WLA4 - Retrofitting Heat Shield (Workshop Campaign)

Vehicle Type: **911 Turbo (991)**

Subject: **Heat shield on rear cross member**

*Installation position of heat shield*

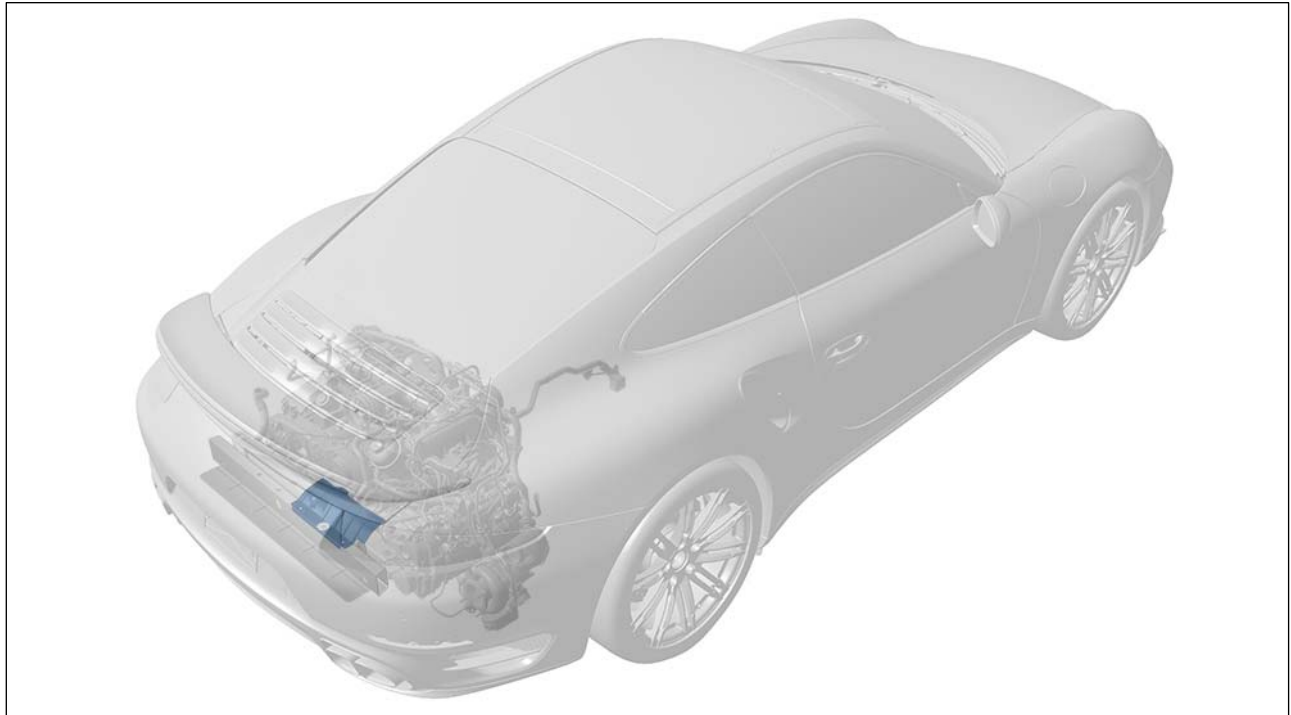
Information: **In the past, there have been isolated incidences of damage caused by fire occurring in the engine compartment.**

Analysis of this damage has identified foreign objects or materials (e.g. cleaning cloths) found in the engine compartment as the cause of these incidents. Foreign objects or materials of this kind can touch hot exhaust system components while driving, causing them to ignite.

Remedial Action: Retrofit heat shield on rear cross member in the engine compartment. This shield may help to prevent any foreign objects or materials from touching exhaust-carrying or hot components in the engine compartment.
